FINAL ENVIRONMENTAL IMPACT STATEMENT REHABILITATION OF  
LOCKS AND DAM NUMBER 1 MINNEAPOLIS MINNESOTA(U) CORPS  
OF ENGINEERS ST PAUL MN ST PAUL DISTRICT JUL 78

FINAL  
 ENVIRONMENTAL IMPACT STATEMENT  
 REHABILITATION OF LOCKS AND DAM NO. 1  
 MINNEAPOLIS, MINNESOTA

**LETTERS of COMMENT  
and  
CORPS RESPONSES**

Figure 7

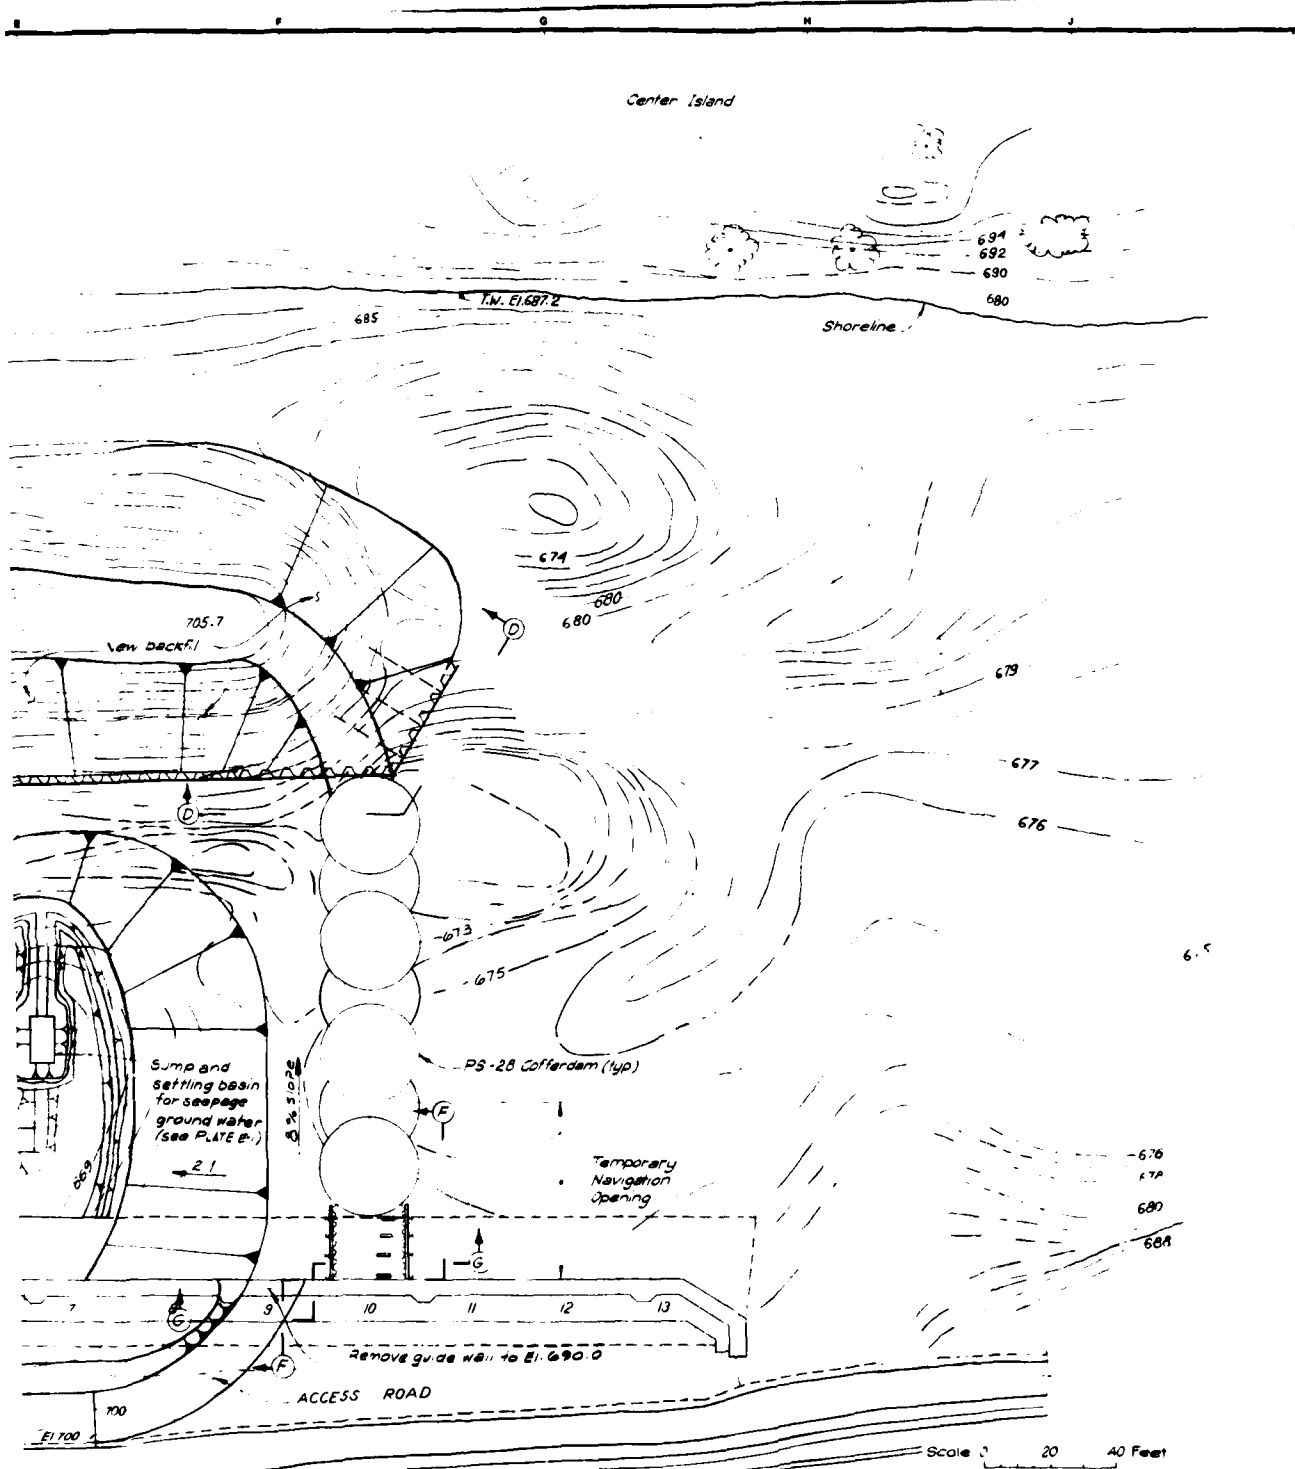
Page 12, Paragraph 1.17 - Cofferdam Construction --  
It is noted that cofferdam seepage water would be pumped directly back into the river. However, figure 7 notes that a settling basin is in the project design. The narrative does not describe the settling basin or predict the degree of settling that is likely to occur. It is suggested the settling basin be further addressed in the final environmental statement

1. As now proposed, the project would not affect the island. The new location of the lower cofferdam is shown in Figure 7.

2. The conceptual design of the seepage and construction water disposal facilities is described in paragraphs 1.13 and 1.15 and shown in Figures 6 and 7. Detailed design of the facilities would be developed during the Plans and Specifications stage of the project. As noted earlier, the seepage water and construction waste water would be kept separate. The amount of settling is not known, but some would take place in both sumps. This material would be removed manually and disposed of.
